DESIGN REVIEW/CERTIFICATE OF APPROPRIATENESS

Project/P	roperty Address or Location:			Project Nam	,		A./ 1
455 N	Morrison Rd			Moo M	oo E	xpress Car \	/vash
Parcel ID	No.(s):	Zoning	Designation:			Total Acreage:	
025-0	03174-00	PUD)			1.87	
Please che	eck all that apply:		ii)				
SI	TE PLAN LANDS	SCAPING	BUILDING	DESIGN	DEWOL	ITION only applicable to Code Chapter	OTHER
	x	x	x	_]	х	1150, Olde Gahanna	
	escription:						
Demoli	tion of exisiting Frisch	's and cons	struction of	a Moo Mo	o Car	Wash facility & o	ıl change.
APPLICA	NT Name -do <u>not</u> use a busir	ness name:		Applicant A	ddress:		
Jeffr	ey Gilger			13375 I	Vation	nal Rd. SW Et	na, OH 43068
Applicant				Applicant P			
jeff@	expresswashcond	cepts.con	n	614-75	1-927	7 4	
BUSINESS	S Name (if applicable):	20 10000 B					
	Moo Express Car						
	NAL CONTACTS Please List	Primary Conto	act for Corresp	ondence(ple	ase list all	l applicable contacts) (phone no./email):	
Name(s):				Conider init	Jillianon	(prione no.) eman;	-

PRIVATE SITE IMPROVEMENTS MOO MOO EXPRESS CAR WASH

Request for Final Development Plan (FDP), Design Review (DR), and Conditional Use (CU) approval to allow for the development of a Moo Moo Express Car Was

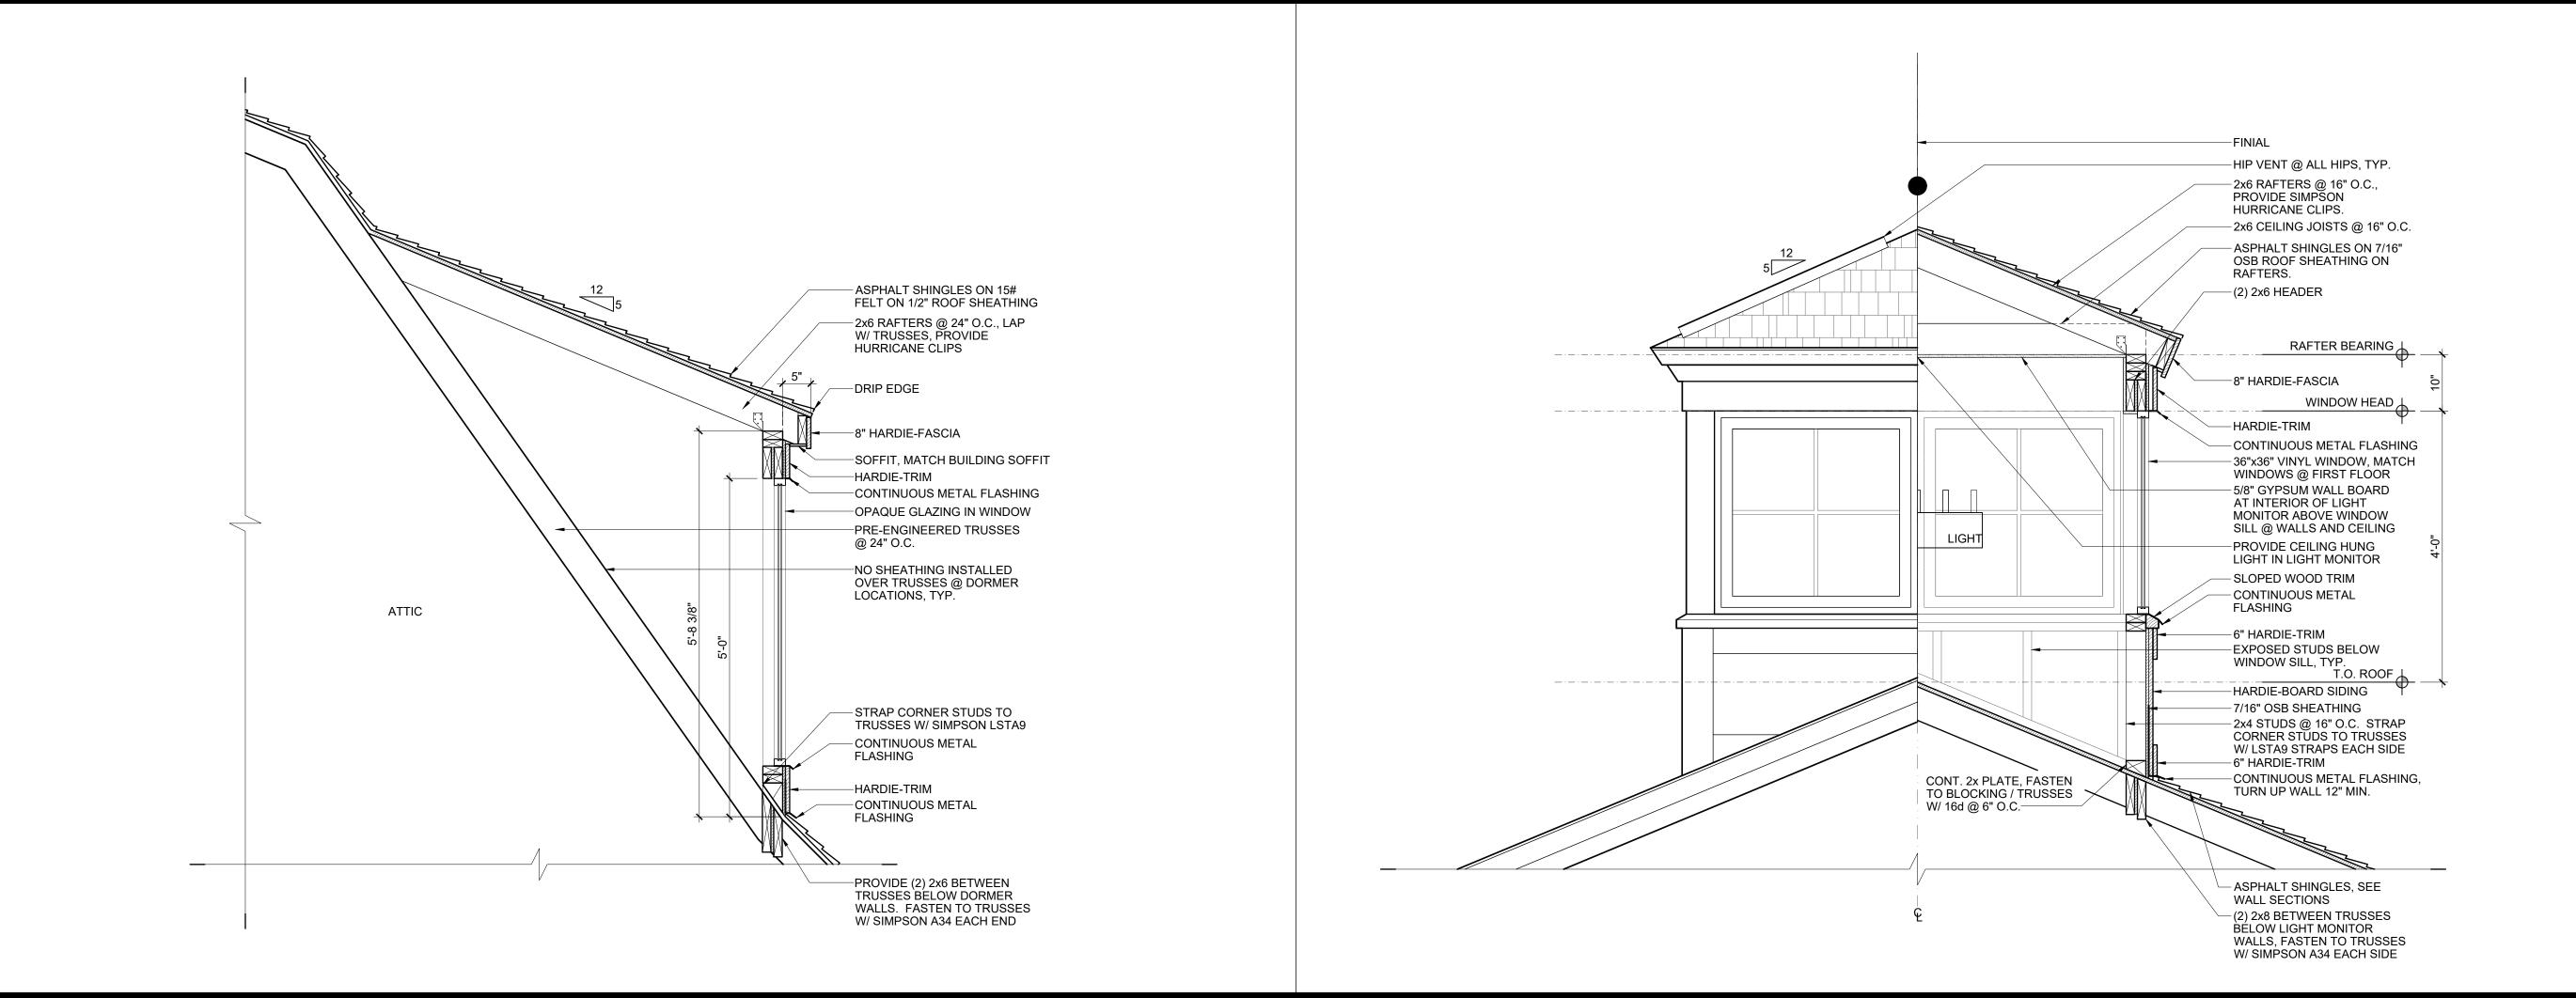
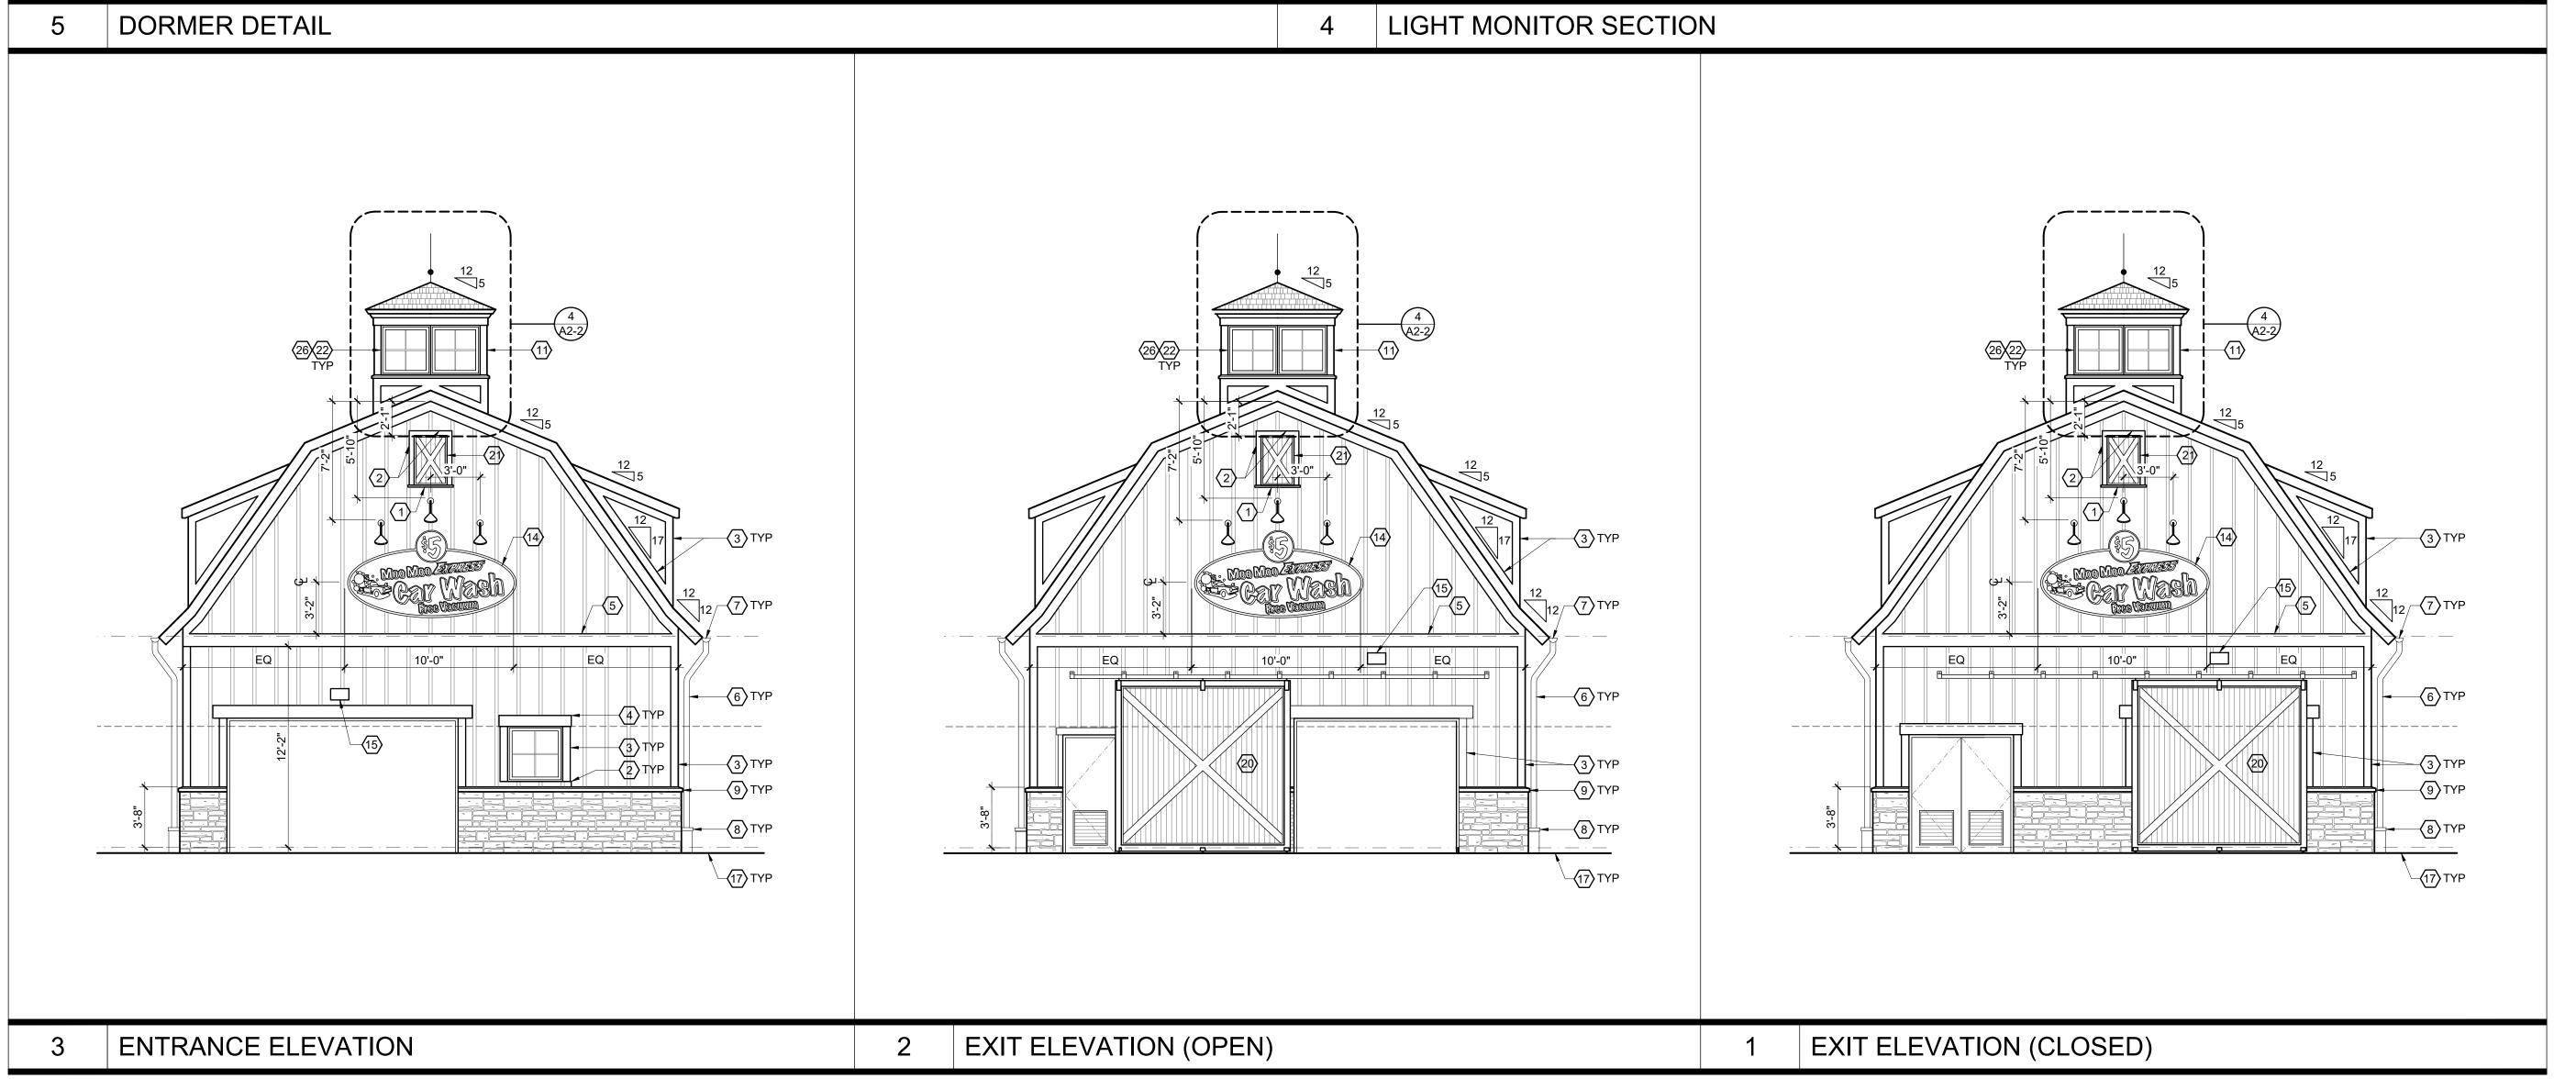
5. The previous application for Granville Street proposed a facility constructed out of brick. Please be aware that Planning Commission and staff may have a preference for brick as the primary building material. Chapter 1197.09 encourages brick as a material within this design review district. It could be determined that brick is more appropriate in this area based on its use as a primary building material in the area.

5/21/21 - Please be aware that design and colors will be discussed with planning commission at hearing. No major issues with staff as proposed, however, the use of brick will be discussed with planning commission. Acknowledged

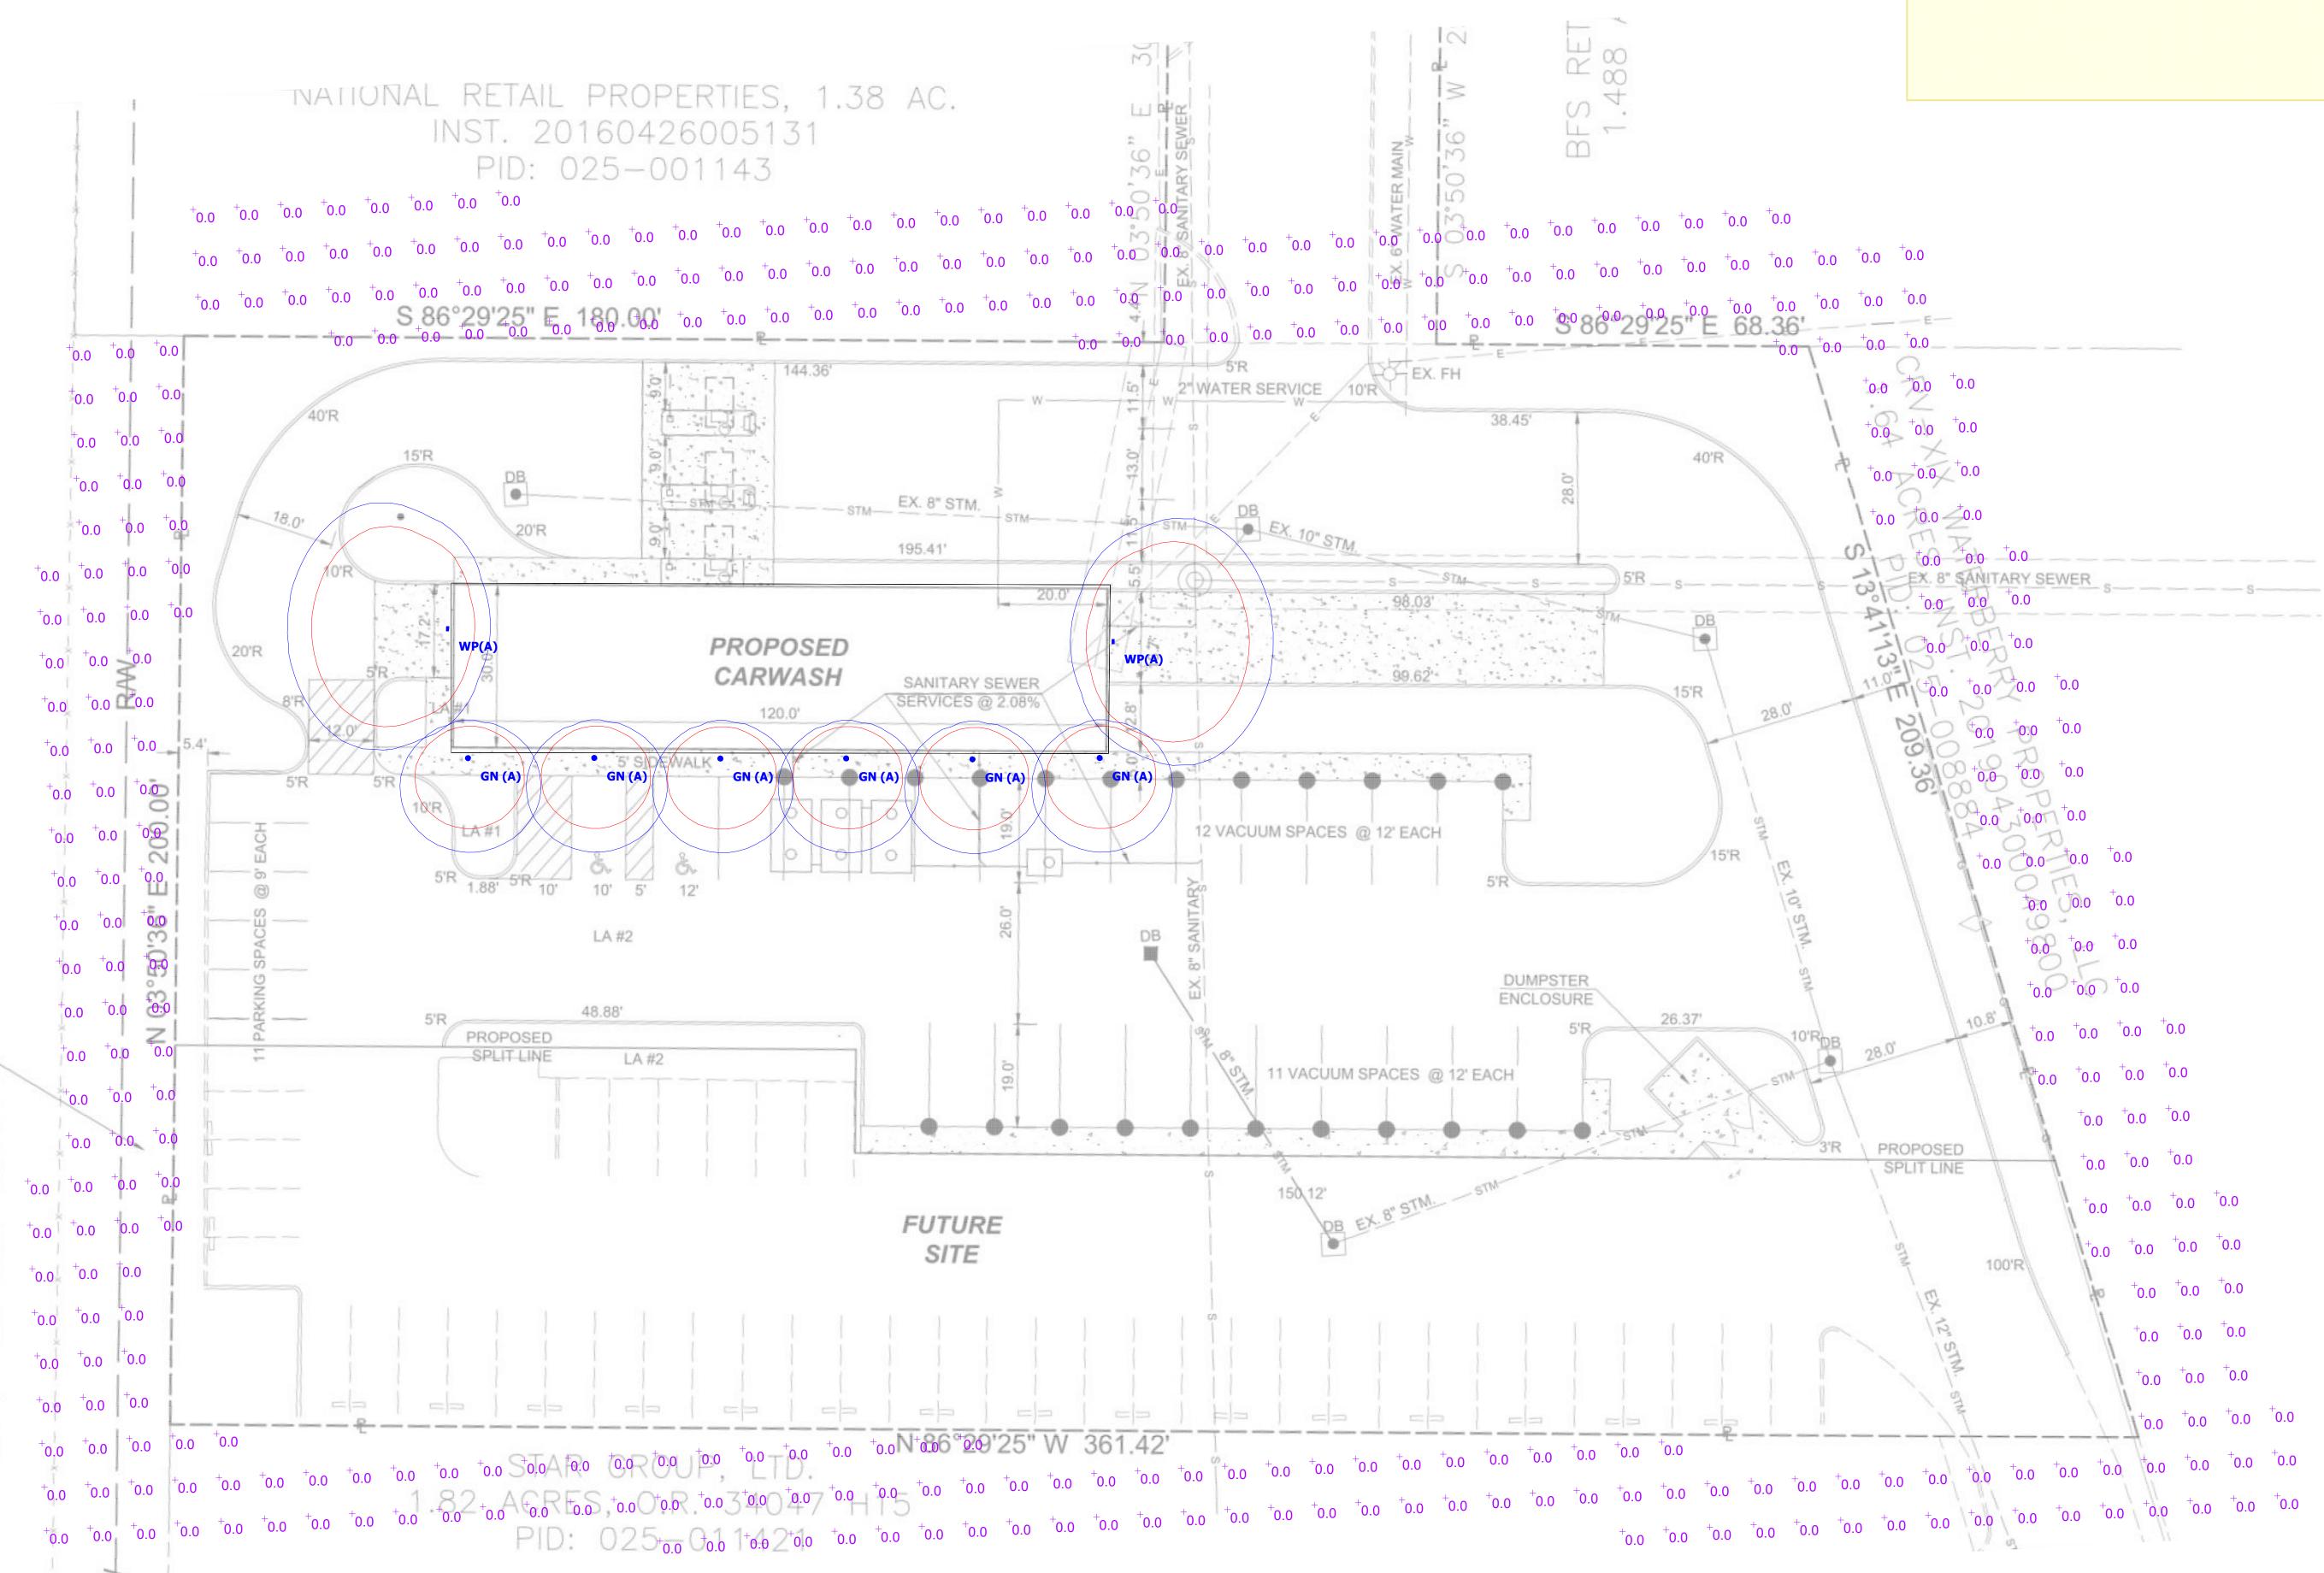
4. The photometrics plan needs to show the lighting level at the property line. A maximum of 1 foot candle is permitted. Please revise accordingly. See below

5/21/21 - Two photometric plans have been submitted. Staff is unsure what the difference between them are. Which plan is the plan that depicts lighting levels after the proposed installation of all onsite lighting? Please clarify.

Both plans show a lighting level that exceeds the maximum allowable allowed. A variance or reduced lighting levels are necessary in order to move the applications forward.

Please see revised lighting plan attached – existing site lighting is to be re-purposed new building lighting meets allowable footcandle requirements.
